Attachment 1: Response to Guidelines: MUP Application for Design Review

The following Design Guidance was offered by the Design Review Board at the September 20, 2018 EDG meeting. The design response is summarized after the EDG report sections (in grey italics).

Figure 6: East Side Comparison

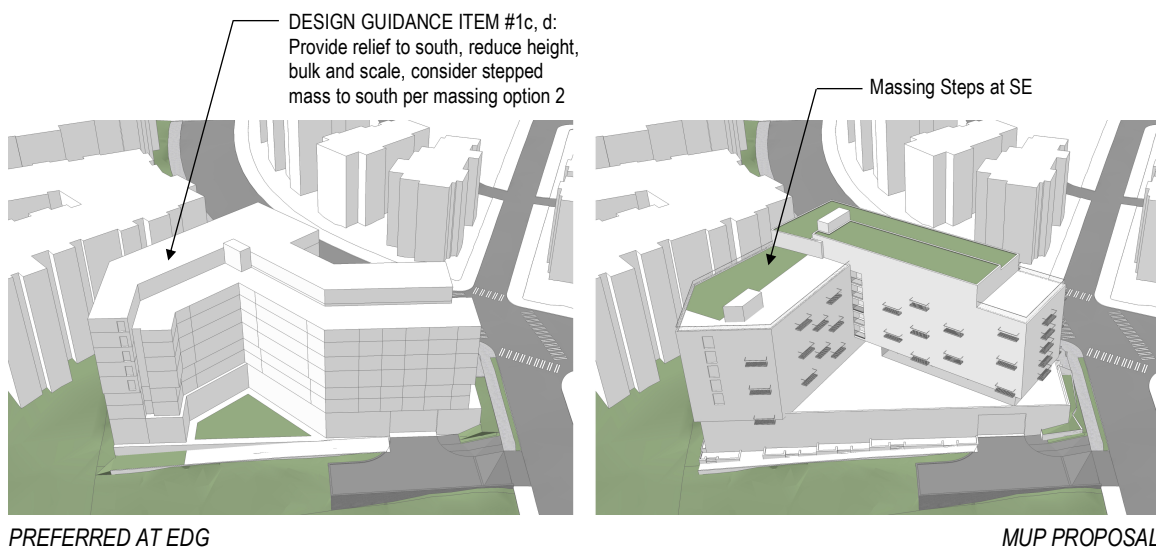
- c. *In response to public comment, the Board directed further development of the mass along the south property line in a manner that provides relief and achieves a successful fit with the adjacent site. The Board encouraged pulling back the upper-levels or otherwise modulating the façade to reduce height and bulk impacts, and noted that the upper-level setback along the east property line may be better positioned along the south property line. (CS2-D-1, CS2-D-5, DC2-A, DC2-C-3)*

- d. *The Board heard public comment regarding the stepped mass in the southeast corner of massing Option 2, and encouraged the applicant to consider incorporating this massing move into the final design to ease the transition with the adjacent site. (DC2-A, DC2-C-3)*

- e. *The Board requested dimensioned cross sections and plans that illustrate the relationship – in terms of building height and separation – between the proposed development and the adjacent site to the south at the Recommendation phase. (CS2-D-1, CS2-D-5)*

The proposal builds upon the concepts shown in the preferred alternate and modifies the scheme to incorporate suggestions from the neighbors, to respond to the board's guidance, and to better respond to site geometry and topography. The MUP proposal incorporates changes to the massing to provide relief on the south and eastern sides of the property. At the southern property line the proposal is pulled back, providing 29 - 42 ft of separation between at the neighboring building to the south. The updated massing also removes a floor from the top of the southern wing to provide better access to light and air for the southern neighbor (CS2-D1, CS2-D5, DC2-A, DC2-C-3, DC3). See Figures 6 and 7.

Figure 8: North Corner Comparison

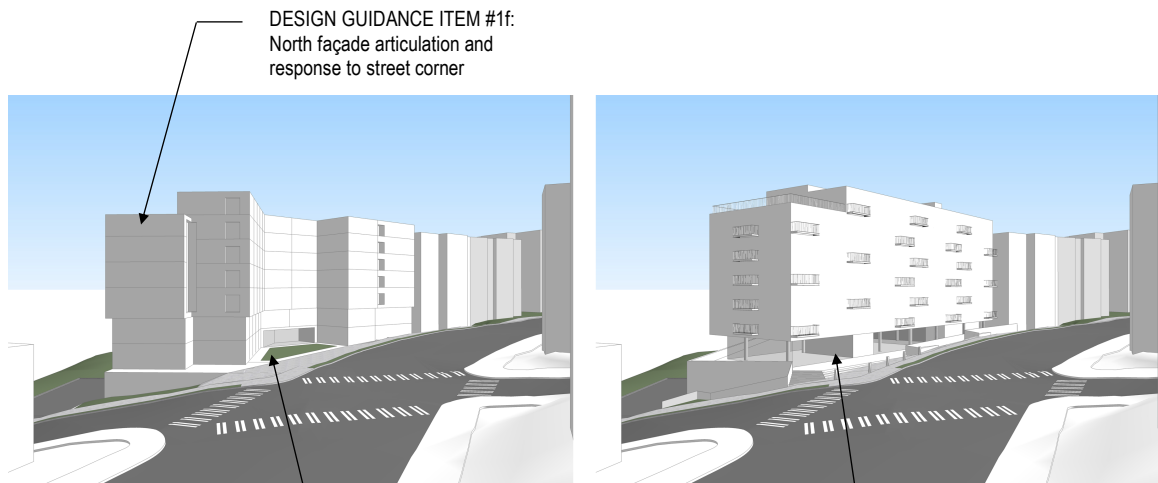
- f. *The Board prioritized Design Guideline CS2-C-1, Corner Sites, and stated that the articulation of the north façade and northwest corner should be strengthened. The design should ultimately hold the corner, while being considerate of traffic patterns. (CS2-C-1, CS2-II-i)*

DESIGN GUIDANCE ITEM #3c:
Courtyard on Avalon concerns

The massing has been modified at the north end of the site to better address the corner and reinforce the street edge while also being setback enough to allow for site lines at the intersection and have a courtyard at the corner. A ground floor commercial space has been added to help activate the street frontage as well (CS2-C1, CS2-III) (See Figure 8).
